14 July 2026

Lot 909, 12 Chalk Street, Woolloowin – Response to Further Advice Notice – Traffic and Transport items

This letter has been prepared to provide a transport response to the traffic related items included within the Further Advice notice, specifically, **item 1(c), item 7 and item 8** of Council's Further Advice notice letter. For reference, Council's items have been reproduced below, with Urbis' response following each item.

Figure 1 – Development West Elevation

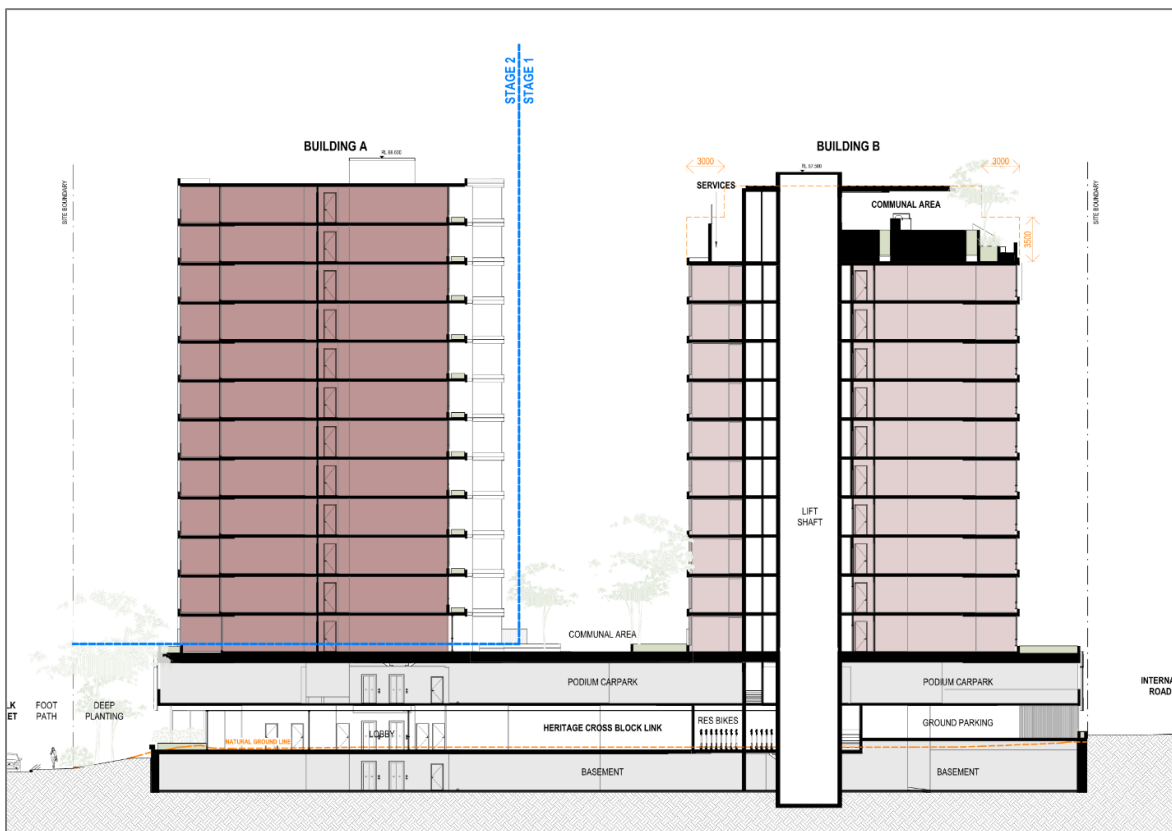
- (c)** *A full set of architectural plans that demonstrate the proposed staging lines, order and functionality between stages. The architectural plans are to include:*
 - i.** *A clear staging line that does not intersect key aspects of the development which are required for the function of Stage 1 or results in the part-delivery of elements in Stage 2. NB: the current Architectural plans detail the staging line through carparks and balconies, which is does not clearly illustrate how these spaces will be delivered.*

A revised staging line has been proposed within the architectural plans which includes all carparking, servicing and manoeuvring areas to be delivered in their entirety as part of Stage 1. The revised staging arrangements have been demonstrated within Figure 1, and provided within the architectural plans provided in **Attachment B**.

With consideration of the revised staging, these arrangements do not impact or intersect any parking, access, servicing or manoeuvring arrangements, nor are any interim treatments proposed within these areas prior to the delivery of stage 2 (including construction of Stage 2).

Figure 2 – Temporary Visitor Bicycle Parking Relocation

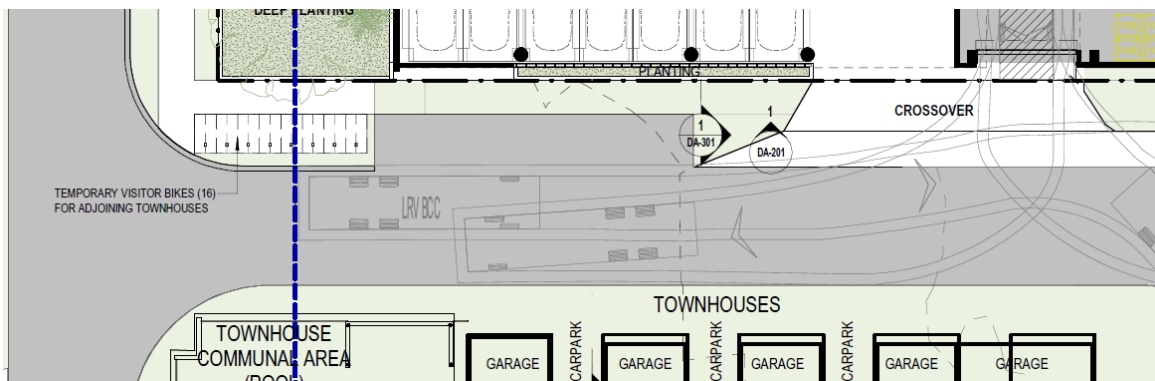
The response to the Information Request has not demonstrated where the existing visitor bicycle parks within the internal road are proposed to be relocated to. Provide amended plans showing where the existing bicycle parking are proposed to be relocated to, ensuring that they maintain compliant visitor bicycle parking rates, in accordance with the requirements of the Transport access parking and servicing code.

It is noted that the temporary visitor bicycle parking spaces provided along the internal road (provided in 8 hoops to service the adjacent townhouses) are impacted by the proposed crossover and have been relocated to the west of the kerbside parking module (as demonstrated in Figure 2 below). The revised location is considered suitable to service the existing townhouses.

1 BUILDING 1 REFUSE ROOM - DETAIL PLAN
1 : 100

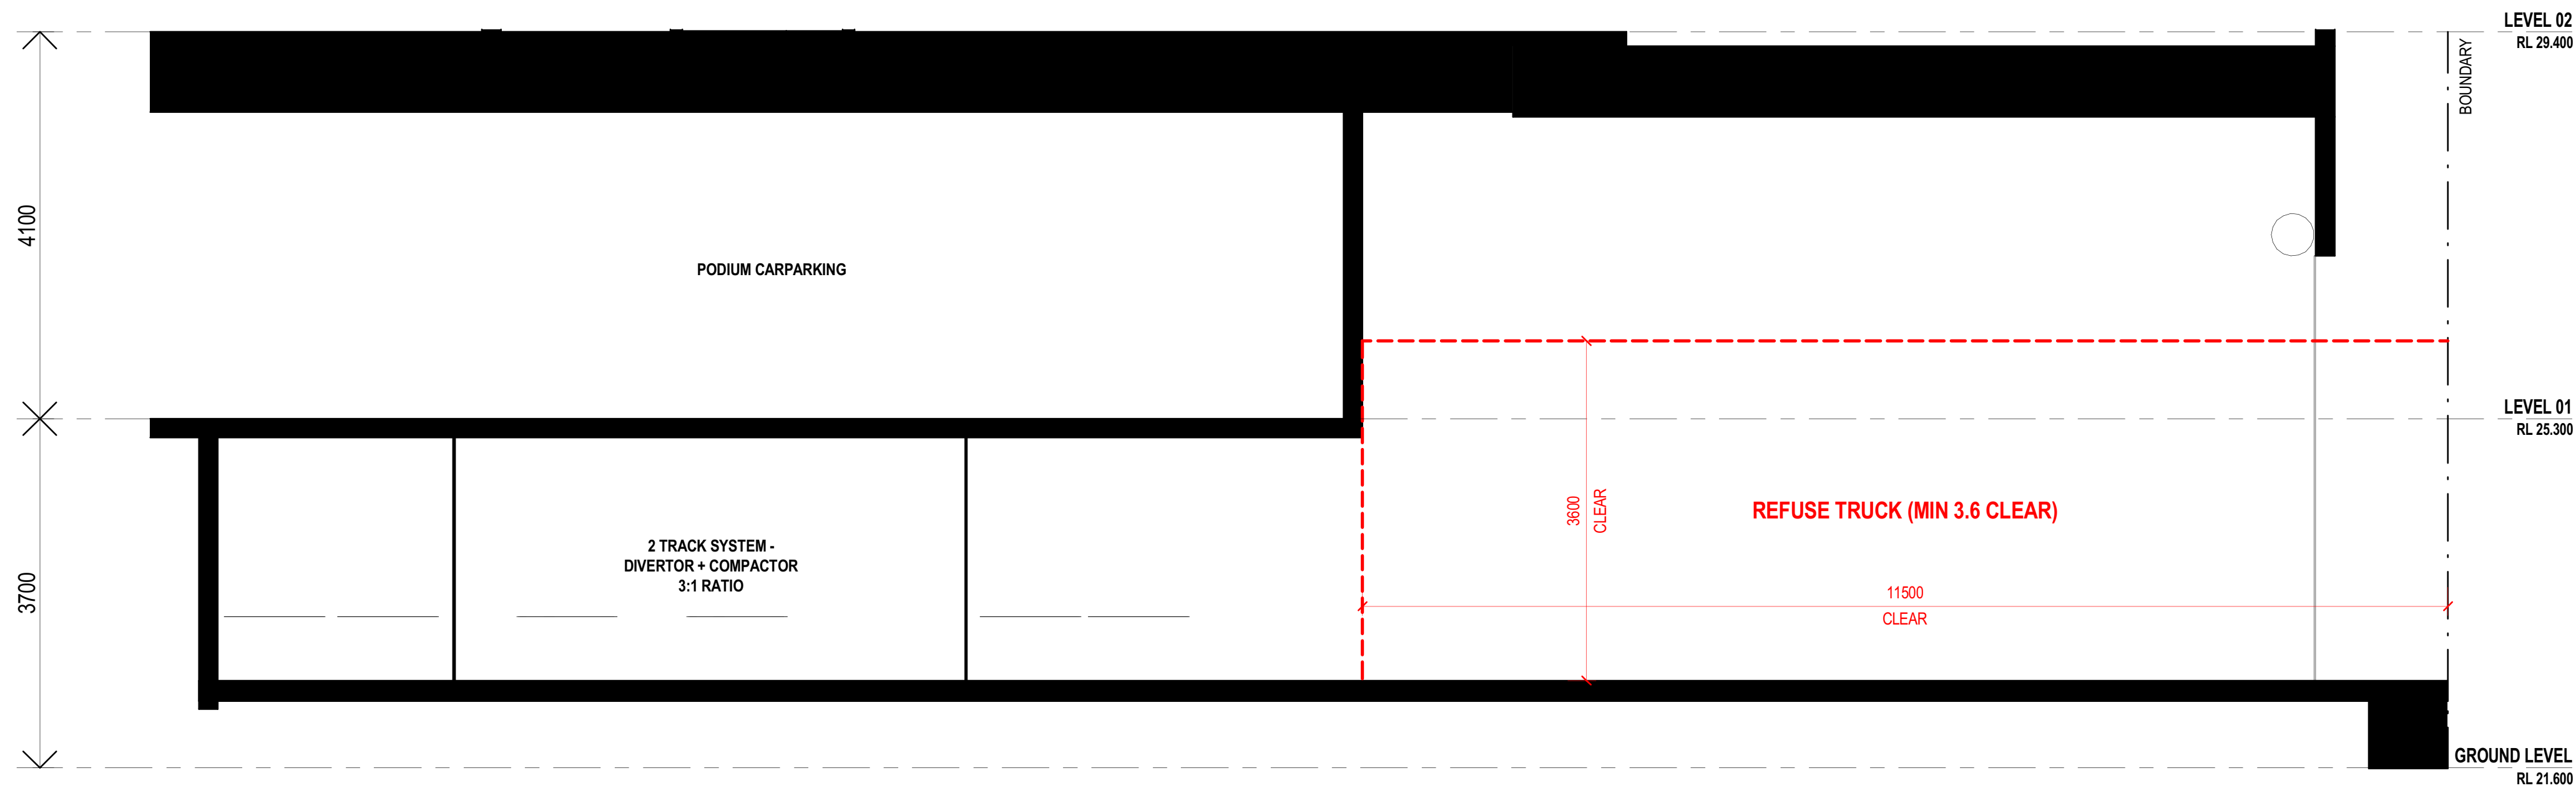
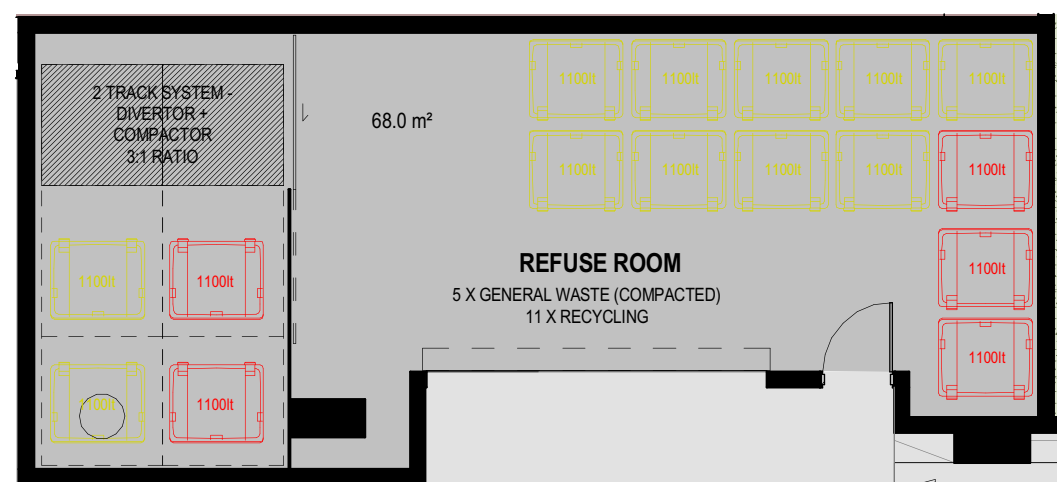
6) The submitted refuse collection response advised that the refuse collection vehicle (RCV) can partly stand within the driveway for servicing to achieve the 11.5m of clearance for servicing. As the internal road is a private road and not owned or managed by Council, compliance against PO19 and PO32 of the Transport, access, parking and servicing code has not been demonstrated. Provide amended plans, demonstrating:

- a. A functional 'Temp Bin Store' that is not blocked by the RCV.
- b. The area where the RCV stands to service the development is a minimum 11.5m long, 6.5m wide and has a minimum vertical clearance of 3.6m across the entire aisle.

It is noted that the Building 1 loading dock has been updated to include a loading bay which measures 11.5m length, 4.3m width (minimum), and 3.6m vertical clearance. These dimensions are consistent with the follow-up advice provided by Council. The dimensions (including loading dock section plan) are included in the architectural plans provided in **Attachment B**.
